DEPARTMENT OF THE ARMY ST. LOUIS DISTRICT, CORPS OF ENGINEERS 9170 LATTY AVENUE BERKELEY, MISSOURI 63134

March 4, 1998

Formerly Utilized Sites Remedial Action Program Project Office

SUBJECT - COLDWATER CREEK SAMPLE RESULTS IN THE VICINITY OF THE ST. DENIS AVENUE BRIDGE

Figure - Coldwater Creek Bridge on St. Louis Avenue

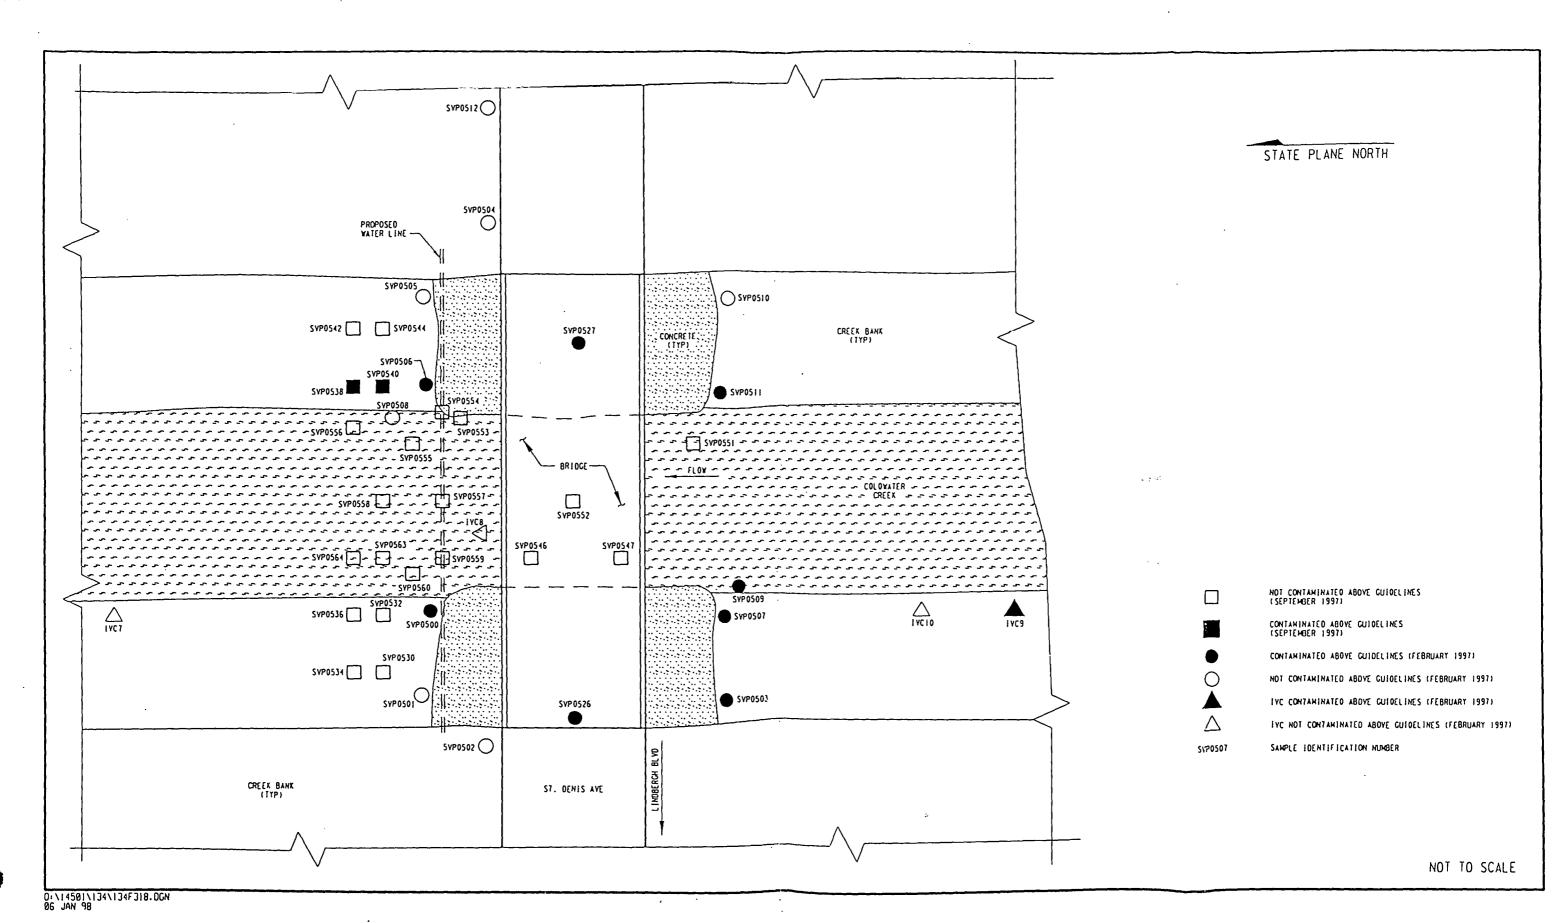
2) It looks like the map of the St. Denis Avenue Bridge and sampling locations includes data from two sampling events. I would say the second sampling event was done in September 1997. When was the first sampling event done?

5) The sample identification and location identification don't match up with the map provided in the letter.

The most recent sampling event was performed in September of 1997 and the earlier bridge sampling occurred in February 1997, as stated in the Coldwater Creek report. This information has been added to the subject figure (see attached).

The sample identifications have been added to the figure for clarity (see attached).
